Request for Additional Information
Model No. Traveller
Docket No. 71-9297

By application dated April 1, 2004, Westinghouse Electric Company requested a Certificate of Compliance for the Model No. Traveller package. This request identifies additional information needed by the Nuclear Regulatory Commission staff (the staff) in connection with its review of the safety analysis report (SAR). The requested information is listed by chapter number and title in the SAR. NUREG-1609, "Standard Review Plan for Transportation Packages for Radioactive Material," was used for this review. This request describes information needed by the staff for it to complete its review of the SAR and to determine whether the applicant has demonstrated compliance with regulatory requirements.

Figure 2-11.1 Clamshell Top Plates

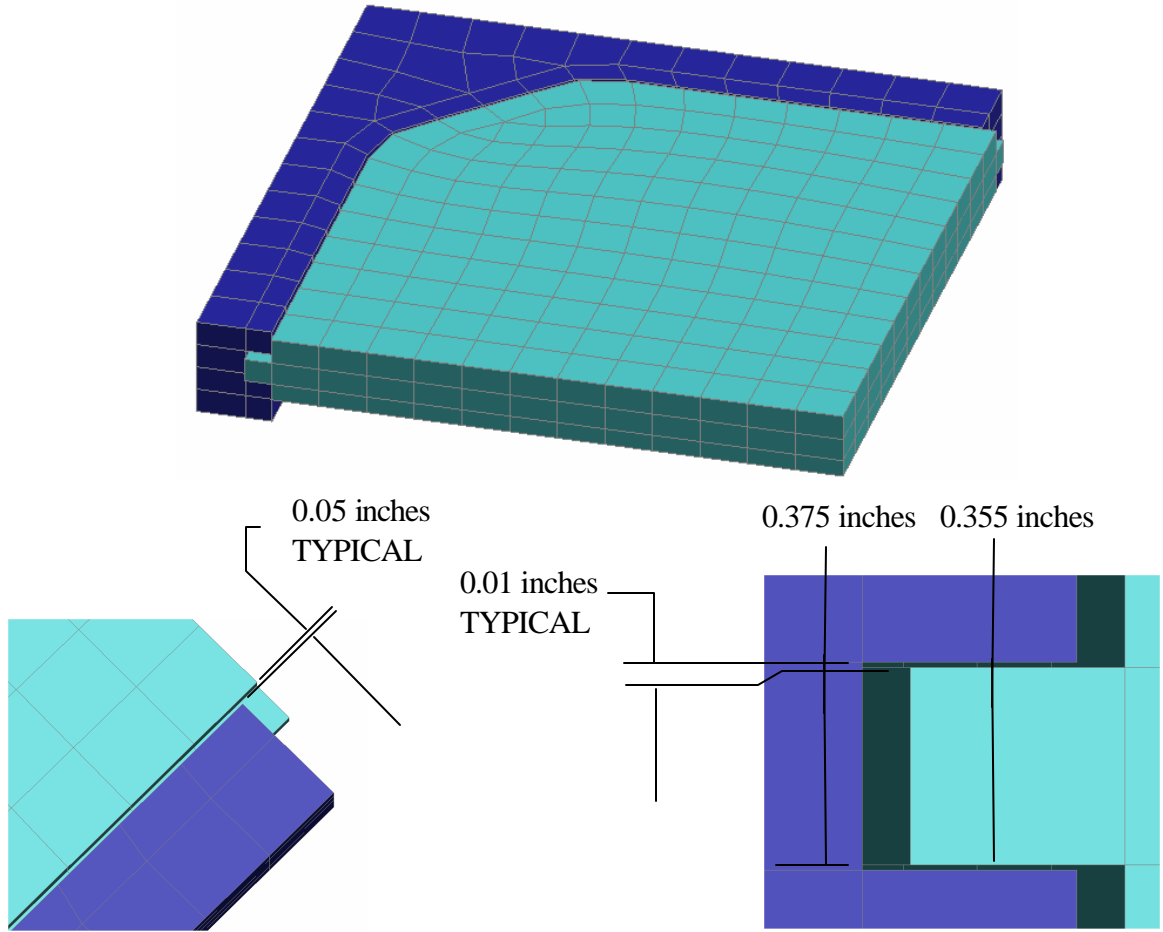
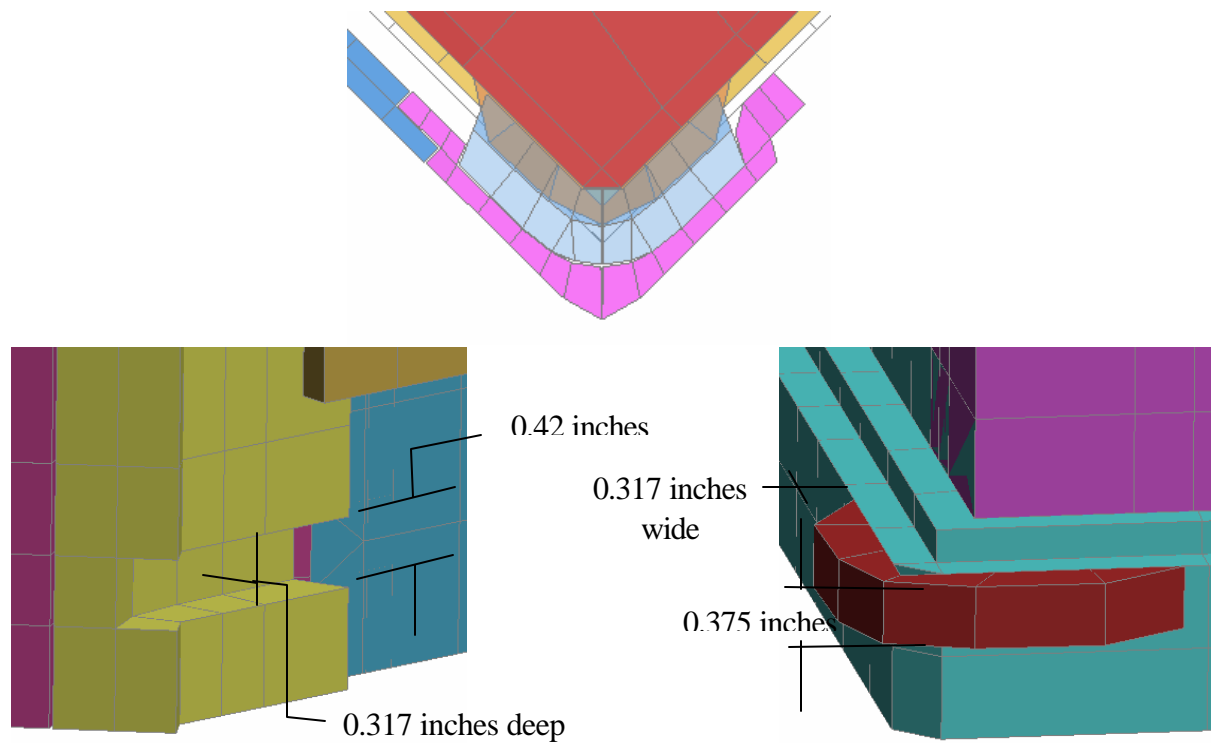
- 2-11 Provide a description of the attributes of and corresponding assumptions for the finite element models for the lipped/grooved interfaces between the Clamshell end plates themselves, at the top end, and between the Clamshell doors and the plate at the bottom end. The application ([pages 2-75, 2-84, 2-96](#)) notes that the Clamshell cross-sectional shape is predicted to stay essentially unchanged during the horizontal drops. Because the predicted deformation of the interlocked end joints will depend primarily on the assumptions made for the finite element model, sufficient modeling details, including gap size, and contact stiffness, if any, must be presented for evaluating the analysis results.

The lipped/grooved interface between the clamshell top end plates is shown in Figure 2-11.1 and the interface between the bottom clamshell plate and doors is shown in Figure 2-11.2.

For the top plates, the 0.355 inch thick lip is positioned within a 0.375 inch thick groove, leaving an axial clearance on either side of approximately 0.010 inches. The clearance in the plane of the plates is 0.050 inches. The axial clearance between the lip on the bottom plate and the groove in the latch is 0.0225 inches on both sides (0.42 – 0.375 inches). In the plane of these plates, there is line to line contact since locking the clamshell door involves rotating the latch until the vertical wall in the latch groove contacts the vertical side of the lip extending from the clamshell bottom plate. Contacts were defined using a penalty-based contact algorithm; contact stiffness was found by dividing the nodal mass by the square of the time step size with a scale factor to ensure stability (LS-DYNA's SOFT=1 contact option). Although there is only metal contacting metal in these two situations, this approach was used because the foam has stiffness that is one or more orders of magnitude less than the metal parts. Further, the stiffness of these parts is of similar magnitude and it is most likely the SOFT=1 option did not influence the contact stiffness determined for these parts.

Figure 2-135 QTU Test Series 2 Drop Orientations

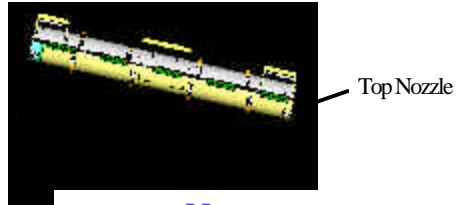
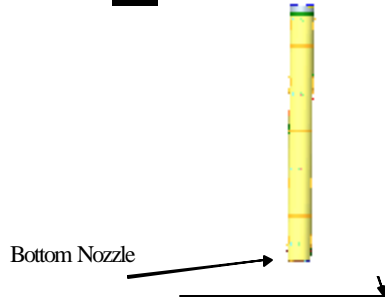
2-14 Correct the following apparent underscored typographical errors, as appropriate:

- Page 2-99, third line from the bottom of the page: “Figure 2-50”
- Page 2-103, fourth line from the top of the page: “Figure 2-41”
- Page 2-104, twelfth line from the bottom of the page: “Figure 2-64”
- Page 2-104, ninth line from the bottom of the page: “Figure 2-82”
- Page 2-104, third line from the bottom of the page: “Figure 2-83”
- Page 2-106, third line from the top of the page: “Figure 2-44”
- Page 2-159, Table 2-32, Item 2.1: “1.2-m NAC drop”
- Page 2-177, Figure 2-135: “Test 2.3”
- Page 2-177, Figure 2-135: “Test 2.4”

- Page 2-99, third line from the bottom of the page: “Figure 2-49”
- Page 2-103, fourth line from the top of the page: “Figure 2-61”
- Page 2-104, twelfth line from the bottom of the page: “Figure 2-44”
- Page 2-104, ninth line from the bottom of the page: “Figure 2-62”
- Page 2-104, third line from the bottom of the page: “Figure 2-63”
- Page 2-106, third line from the top of the page: “Figure 2-64”
- Page 2-159, Table 2-32, Item 2.1: “1.2-m NAC drop” (No correction needed)
(Added reference for Table 2-32 to page 2-158)
- Page 2-177, Figure 2-135: “Test 2.3” (Replaced Figure 2-135)
- Page 2-177, Figure 2-135: “Test 2.4” (Replaced Figure 2-135)

Figure 2-15.1 Shock Mounts in Qualification Unit Model

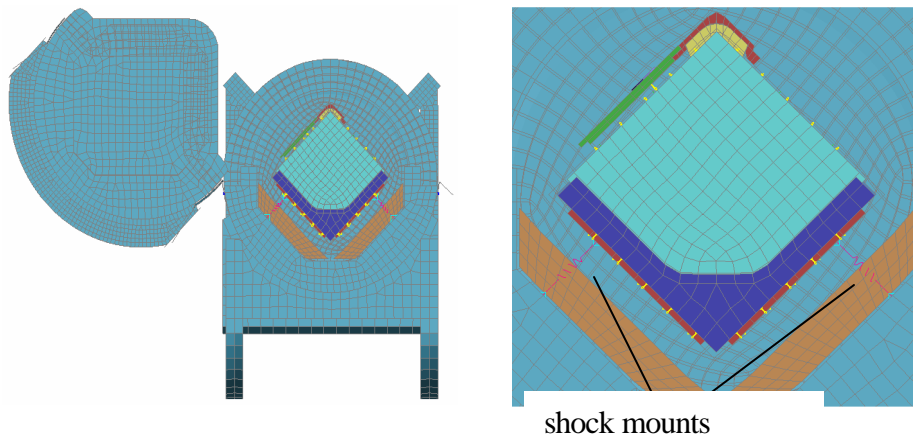
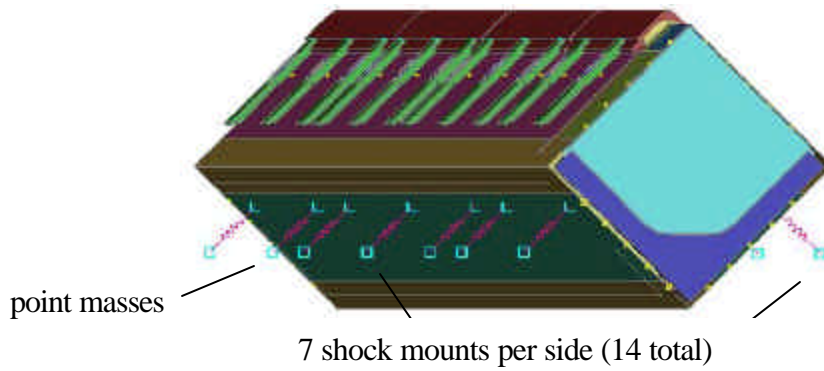
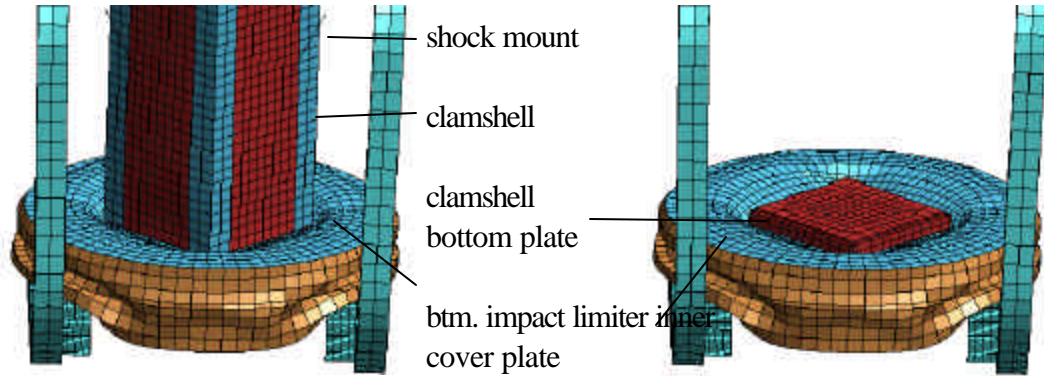
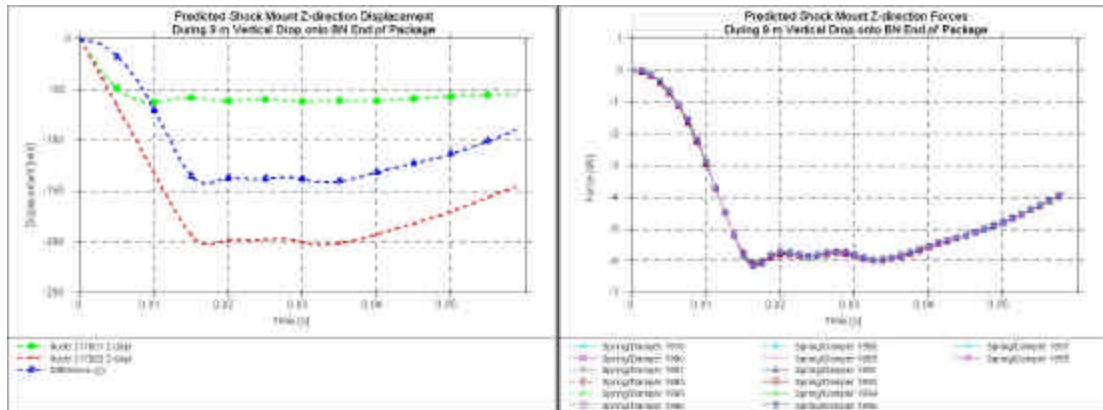
- 2-15 Provide a description of relevant model attributes, including use of sketches, to clarify the statement made on page 2-102, “[t]he vertical load developed by shock mounts is negligible and was ignored.” It is not clear from the information provided how the Clamshell loads and accelerations are defined with respect to the Clamshell shock mounts layout.

The quoted statement in the SAR is incorrect on two counts. First, the loads exerted on the clamshell by the shock mounts are not negligible. Secondly, they were not neglected. Rather the clamshell accelerations stated for the vertical drops 605 and 843 kN (Section 2.12.3.2.5 and Figure 2-57) loads are actually lower due to the loads exerted on the clamshell by the shock mounts. This is explained below.

For vertical drops onto the bottom end of the package, the clamshell loads and accelerations are defined by the contact forces between the clamshell bottom plate and the bottom impact limiter inner cover plate. Similarly, the contact forces between the top clamshell plates (the grooved plate and the lipped plate) and the top impact limiter inner cover plate were used to determine clamshell loads and accelerations for the vertical (and near vertical) drops onto the top nozzle end of the package. This is illustrated in Figure 2-15.3 for a vertical drop onto the bottom nozzle end of the package.

The loads on the clamshell due to the shock mount extension are calculated using $F=k\delta$. For the vertical case, the spring constant, k , is 42.3 N/mm. Further, the shock mount extension, δ , is the difference in the z deflection of the end nodes of the shock mounts (Figure 2-15.4). Finally, the total vertical force on the clamshell from the 14 shock mounts is summed from the 14 individual contributions. Thus, the maximum z-direction force exerted on the clamshell by the 14 shock mounts was approximately 85.4 kN (6.1 kN x 14). Further this load level was maintained from 0.016 to 0.033 seconds after initial impact.

This load is considered in the 843 kN vertical clamshell force predicted for the vertical drop onto the bottom nozzle end of the package. (A similar load is considered in the predicted 605 kN clamshell load for the vertical drop onto the top nozzle end of the package.)

Figure 2-63A Predicted Temperature and Foam Density Effect on Outerpack/Drop Pad Interface Forces (9m Vertical Drop onto the Bottom End of the Package)

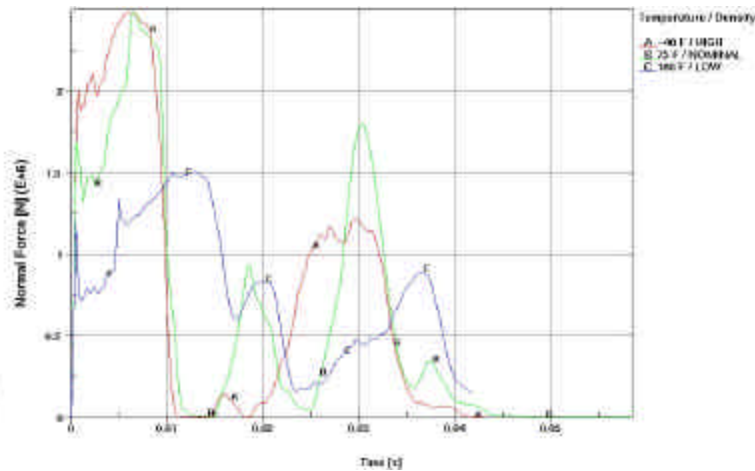
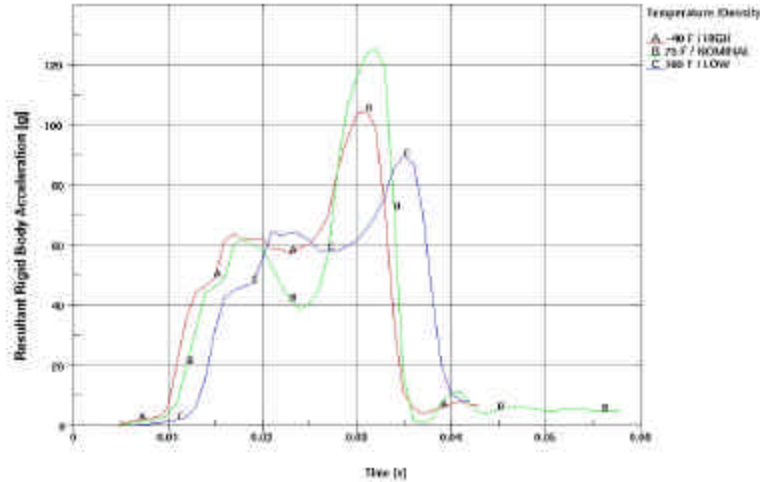
- 2-16 Revise Section 2.12.3.2.6 to include a reevaluation of effects of temperature and foam density change on the drop test performance of the Traveller package, considering a 9-meter bottom-end down drop test.

Temperature/foam tolerance effects for the 9 meter vertical drop onto the bottom nozzle end of the package were evaluated for the three previously noted conditions. Both predicted outerpack/drop pad force histories and fuel assembly accelerations were compared as shown in Figures 2-63A and 2-63B.

Both of these figures predict that the highest forces occur when the package is 24°C (75°F) with the package having nominal foam density. (This does not necessarily mean that a package dropped at 24°C/75°F having foam densities at either the high or low end of the tolerance band would have had lower outerpack/drop pad forces and lower FA accelerations since that was not investigated.) In particular, the predicted maximum outerpack load for the 75°F (24°C)/nominal foam density scenario was 2.5E6 N. This was equal to that predicted for -40°C (-40°F) with foam density at the upper end of the tolerance band and about 67% greater than the 1.5E6 N load predicted for 71°C (160°F) with foam density at the lower end of the tolerance band. Moreover, a maximum FA acceleration of 126 g’s was predicted for drops at 24°C (75°F) with the package having nominal foam density. This was approximately 20% higher than the 105 g’s predicted for the -40°C (-40°F) with foam density at the upper end of the tolerance band scenario and approximately 40% higher than the 90.1 g’s predicted for 71°C (160°F) with foam density at the lower end of the tolerance band case.

Figure 2-91 Predicted and Measured Y Accelerations

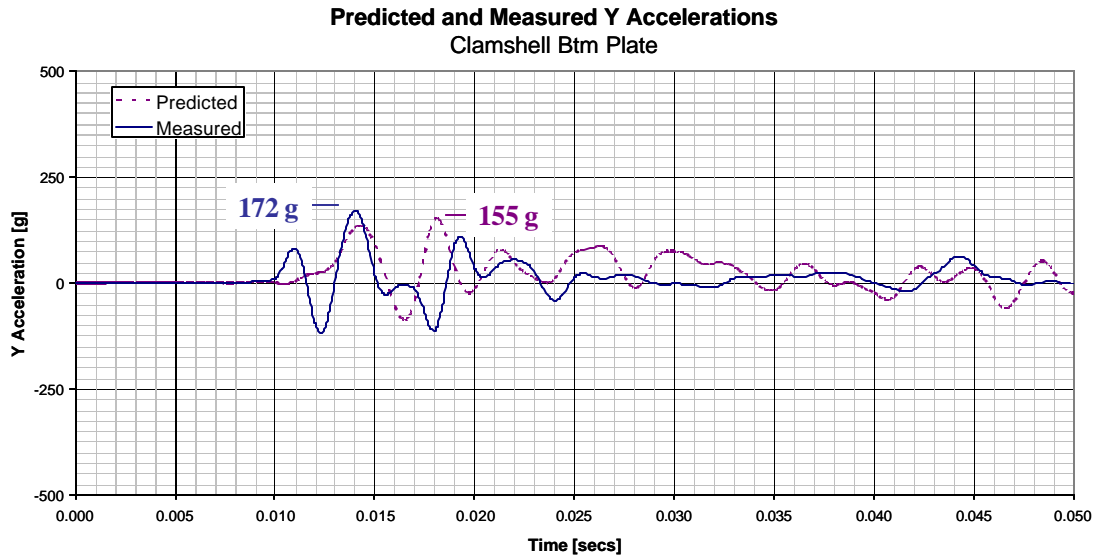
- 2-17 Verify annotation for the measured “Y - Axial g-force” for Figures 2-89 and 2-119. Annotations for the drop response traces are confusing. Throughout the application, the Y coordinate appears to have been assigned to “Vertical,” in lieu of “Axial,” responses such as that of “Y - Vertical g-force” of Figure 2-118.

No change was required to the text of the SAR. Figure 2-91 was replaced.

The container coordinate axes are defined in Figure 2-103 of the SAR and perhaps better illustrated in Figure 2-23. As shown in these figures, the Z-axis is the axial coordinate and is positively directed going from the BN end to the TN end of the package; the Y-axis is perpendicular to the ground and directed upwards when the package is resting on its legs; and the X-axis, defined by the right-hand rule, goes through the plane of the lower and upper overpack mating surfaces. The accelerometers are fixed to the container and the accelerometer axes were aligned with the container axes.

It should be noted that the orientation of both the container and accelerometer coordinate systems change with respect to the ground depending on drop orientation. Further, the orientation between the coordinate axis and the ground generally changes during testing as the package rotates during the accident. For the case of the low angle slap-down test that was monitored with accelerometers and compared with analytical predictions (Test 1.1), the package was initially oriented at an angle of 14.5 degrees relative to the ground (Figure 2-78) and the first impact occurs with the package so angled. The second impact, however, occurs after the container has become horizontal. Thus, the accelerometer traces shown reflect a change in orientation of approximately 14.5 degrees. The predictions shown in the traces neglect this small change. Rather, the predicted traces are global vertical accelerations (normal to the ground).

Figure 2-117A Accelerometer Locations on Prototype Drop Test

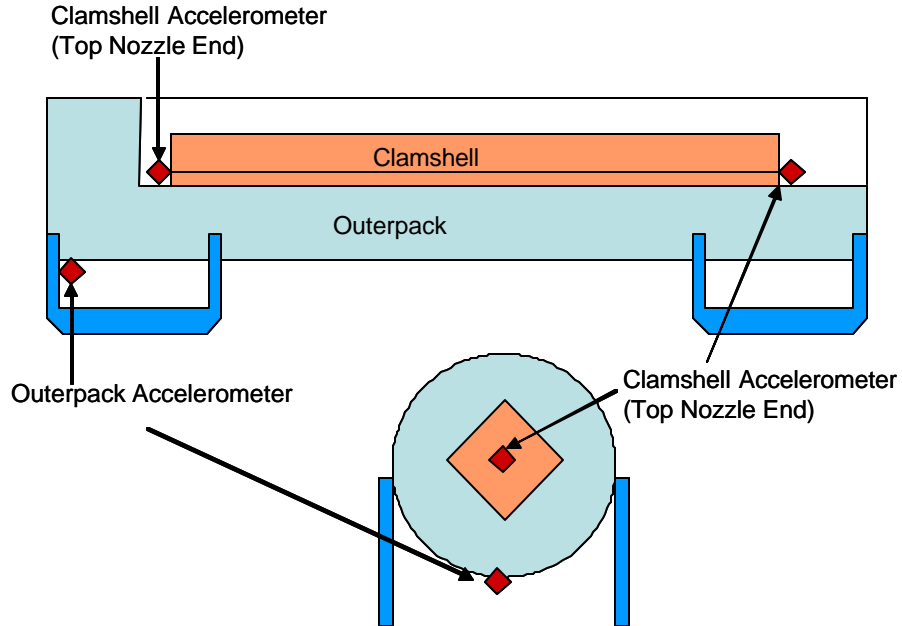
- 2-18 Provide sketches depicting the accelerometer installation plan for the drop tests. The application should include accelerometer locations on the test articles to evaluate correlation between the measured and predicted results.

The following text and Figure 2-117A have been added to Section 2.12.4:

The locations of these accelerometers are shown in Figure 2-117A.

Figure 2-108 Stress-Strain Characteristics of Aluminum in Clamshell

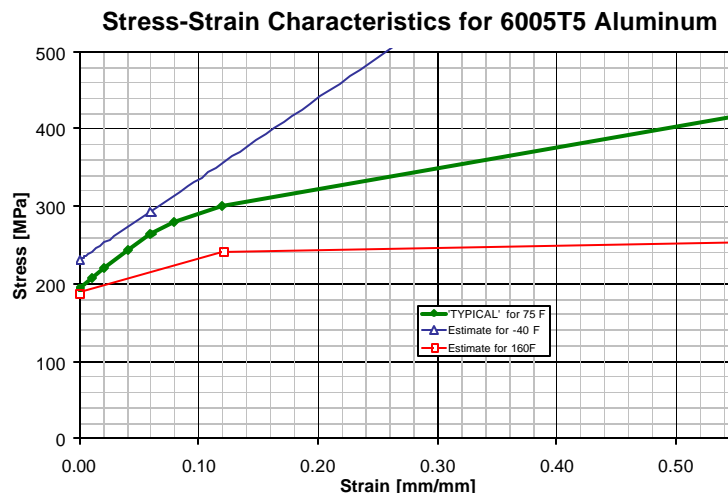
- 2-21 Verify the temperature-dependence stress-strain curve plots, Figure 2-108, for the Clamshell aluminum at 160° F and -40° F. The stress-strain curves at the two temperatures appear to have been mislabeled.

The following figure, Figure 2-108 has been replaced:

Figure 2-105A Foam Response at Strains from 0-10%

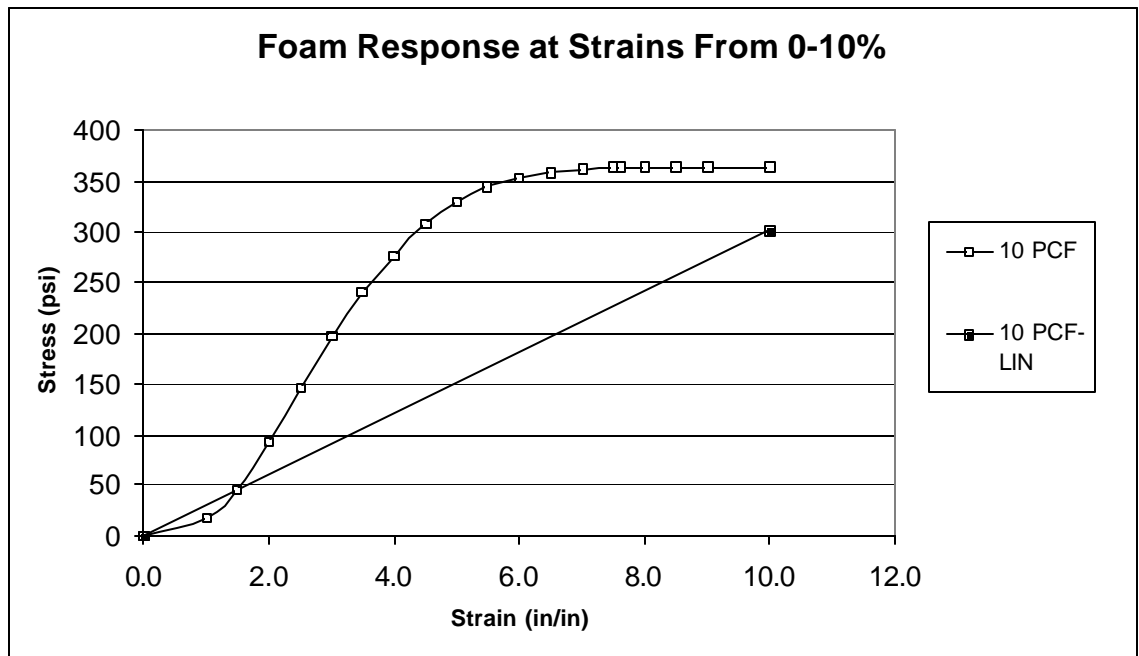
- 2-22 Revise Figure 2-105, as appropriate, to provide detailed stress-strain data for the strains ranging from zero to ten percent. Also, re-evaluate the bottom end drop to determine effects

of cold temperature on package structural performance by using relevant stress-strain data in the finite element analysis. The staff notes that there are no stress-strain data reported for the strain range cited above. By assigning a yield point at the 10-percent strain offset, which had not been substantiated, the result was an assumption on the rate of momentum change of the free dropping package to dictate certain analysis outcomes.

The following text and figure has been added to Section 2.12.3.6.2:

The use of a linear elastic material model from 0-10% strain was selected to evaluate the effects of temperature and foam density on drop test reaction forces. From Section 2.12.3.2.6, foam linear data demonstrated that temperature and foam density have a minor effect on the drop test response of the Traveller. The use of true stress-strain data ranging from 0-10% would not impact the conclusions of the comparative analysis.

A typical comparison of foam stress-strain behavior demonstrates that the available strain energy of a linear model is less than that observed with true stress-strain data. The use of true stress-strain data is expected to result in greater foam deflection when compared to linear modeling. Since greater crushing would absorb more kinetic energy, the predicted reaction force of the outerpack using true stress-strain data is expected to be less compared to linear data. It is concluded that the use of linear stress-strain data in the 0-10% range adds additional conservatism to the model.
